Hill of Fare Wind Farm: combined NatureScot and RSPB Scotland EIA Report comment response

Thank you for providing comments (summarised in **Annex A** for ease of reference) on the Hill of Fare Wind Farm EIA Report. This letter addresses the request for a revised red kite cumulative collision risk assessment (**Annex B**).

ANNEX B. REVISED RED KITE CUMULATIVE COLLISION RISK ASSESSMENT

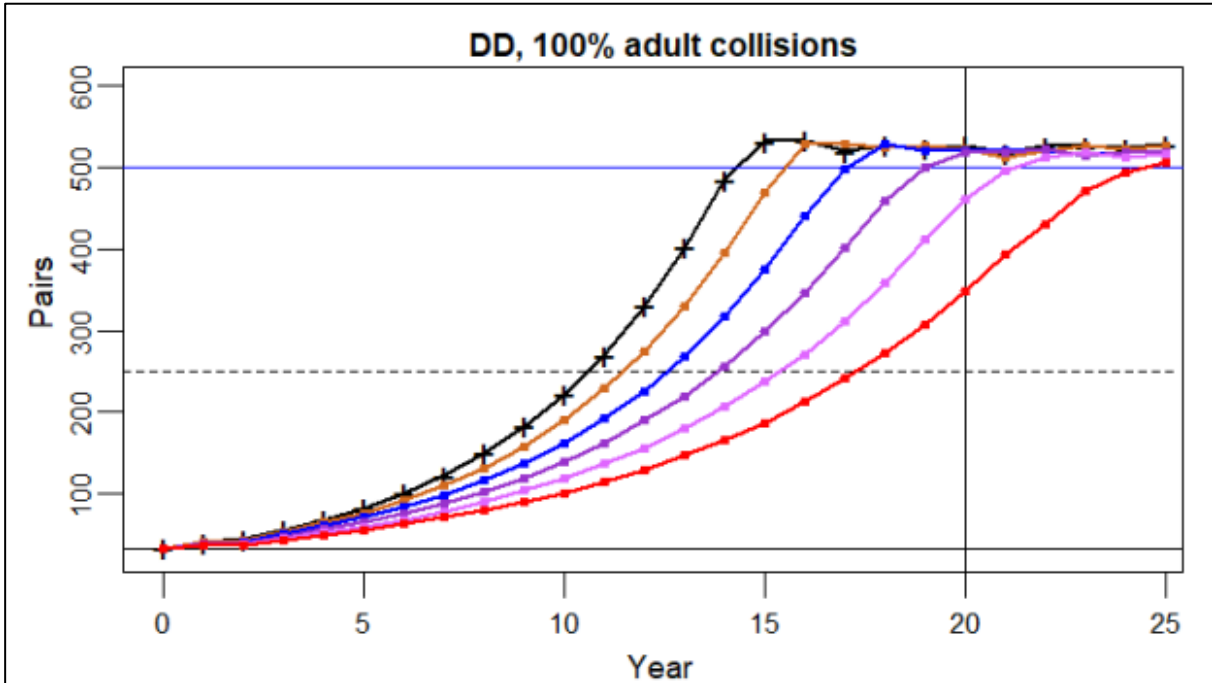
Although it is acknowledged that there may be additional mortality attributable to operational wind farms in the area where collision risk predictions were not available (Table 1), it is unlikely that the cumulative impact from these sites would result in a considerably larger percentage of the population than already predicted (e.g., unlikely to reach 5% of population), so as to alter the trajectory of the population growth predictions as shown on Figure 1.

Therefore, despite the level of additional mortality on the Aberdeenshire and Angus red kite population, it is considered that favourable conservation status can still be attained/maintained over the long-term. The unmitigated impact of cumulative collisions on the Aberdeenshire and Angus population is therefore continued to be considered of low magnitude, and thus minor adverse and not significant in the context of the EIA regulations.
